# **AUBURN PLANNING BOARD MEETING**

Re: Special Exception and Site Plan Review for a:  
Family Dollar Store proposed at 850 Minot Ave., (PID # 207-078)

RE: Proposed Family Dollar Store  
850 Minot Avenue  
Auburn, Maine

A	ISSUED FOR CITY REVIEW	02/07/14
No.	Revision/Issue	Date
Design by:	MPM	Checked by: SJB
Drawn by:	JAR	Approved by: SJB
Project:	131.06141	Date: FEBRUARY 7, 2014
Sheet No:	<b>C-102</b>	
	Sheet 4 of 8

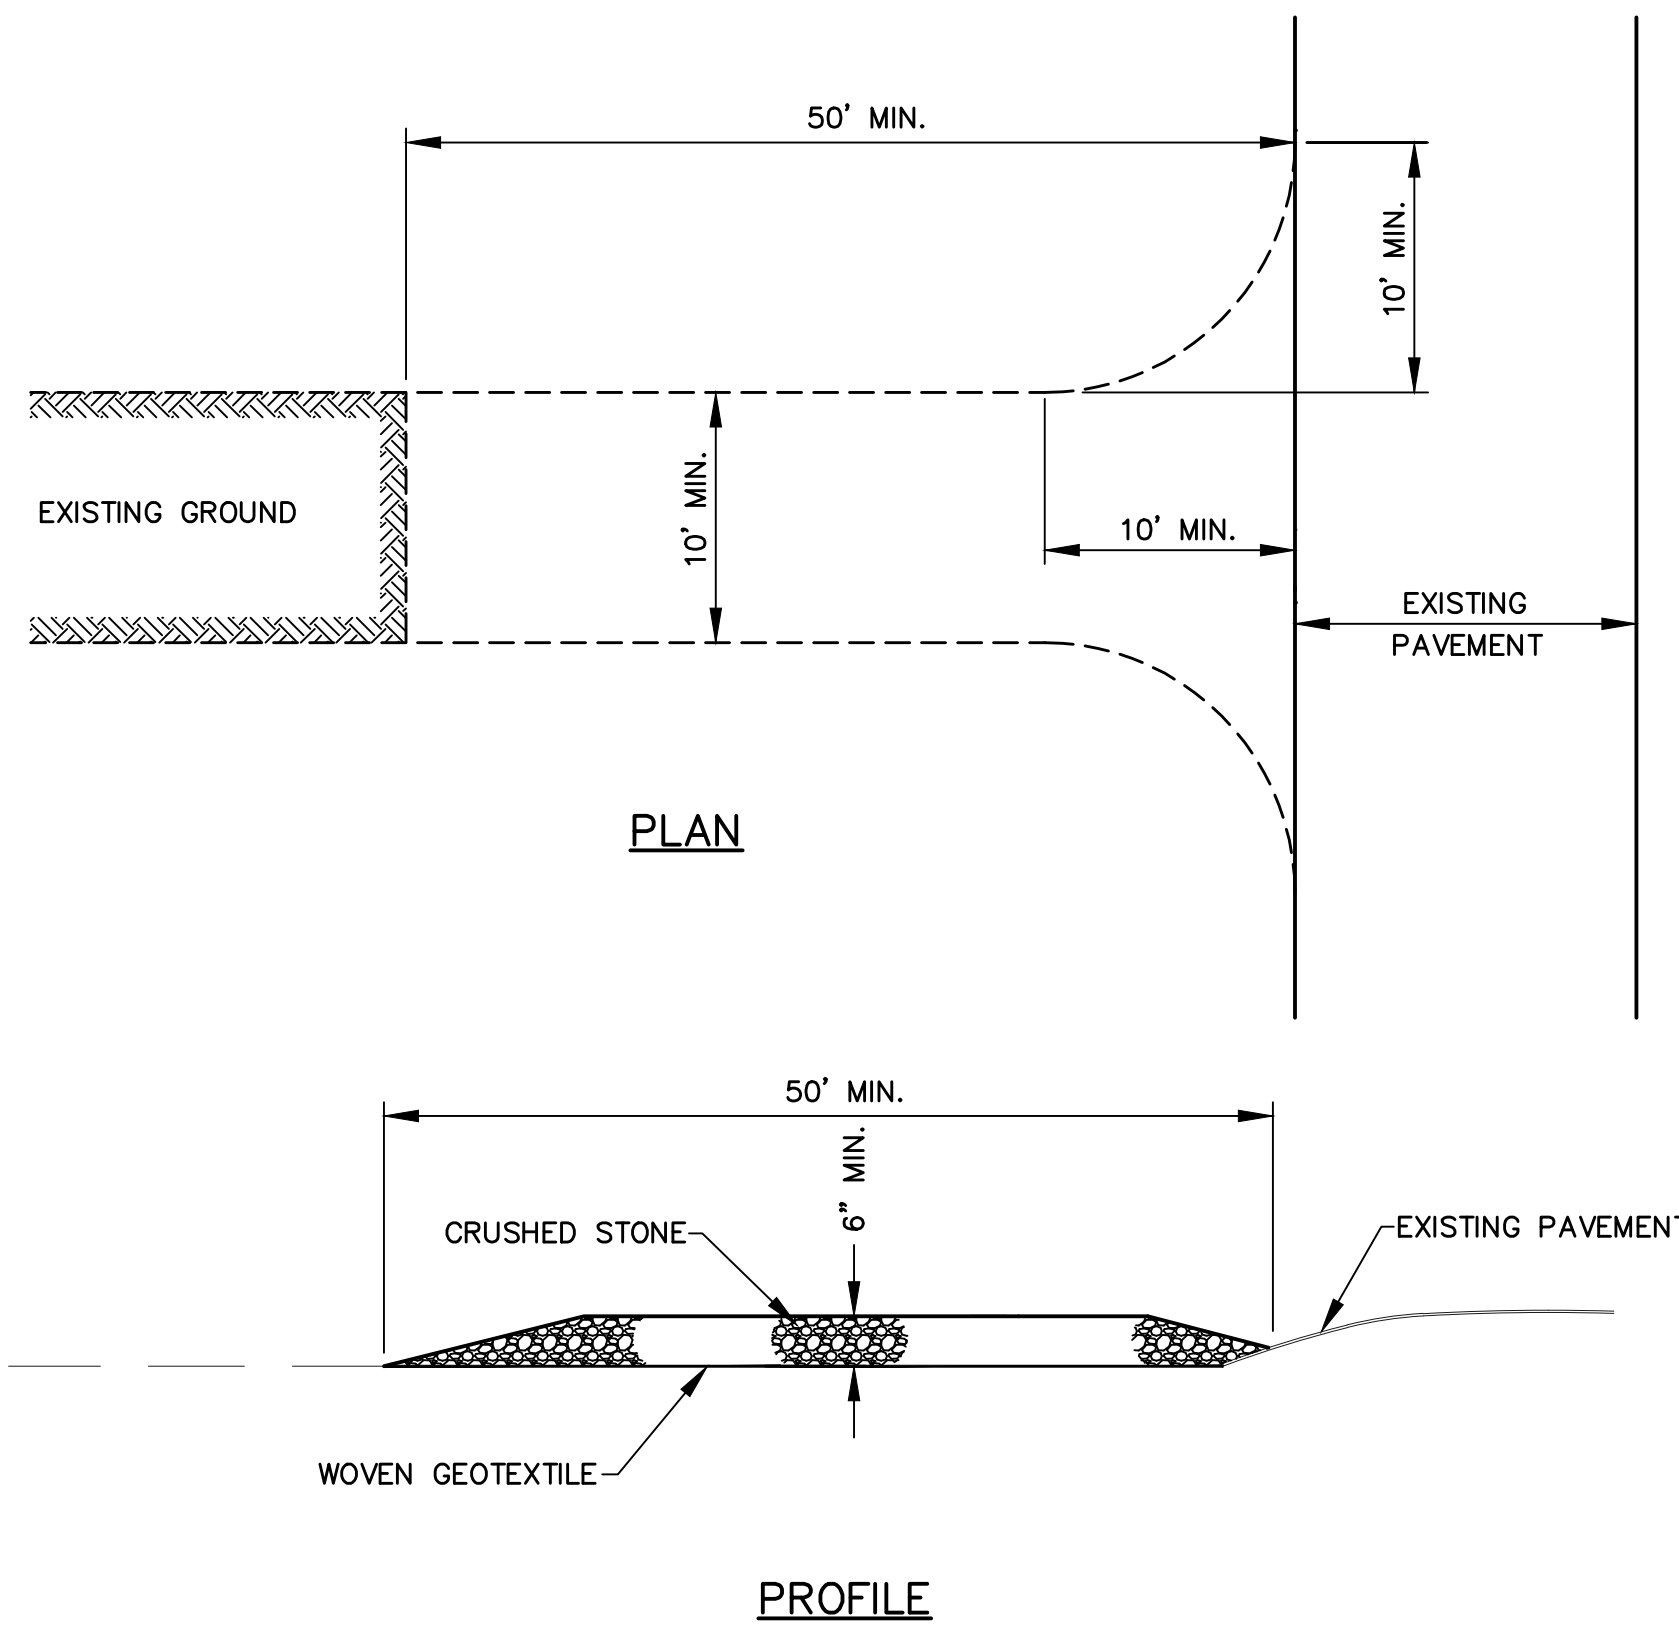
The Water and Sewer District raised concern over the location of a concrete utility pad near an existing sanitary sewer easement. The applicant has moved that utility pad to the rear portion of the building where no utility easement conflict exists. The site plan also includes a relocated utility pole close to the existing sanitary sewer easement along the western boundary of the property.

As you pointed out to me, we have a concern with the most recent design plans dated 2/7/2014. Drawing C-102 (Utility Plan) shows the proposed installation of a new utility pole and underground electric service to the building. The pole is nearly on top of the existing sewer line, as is the underground electric conduit. We have a 20' easement for the sewer line, and would like to see the pole and service relocated out of the easement area.

I see the latest plan shows that the concrete utility pad has been moved from the location previously shown on sheet C-100 of the December plan.
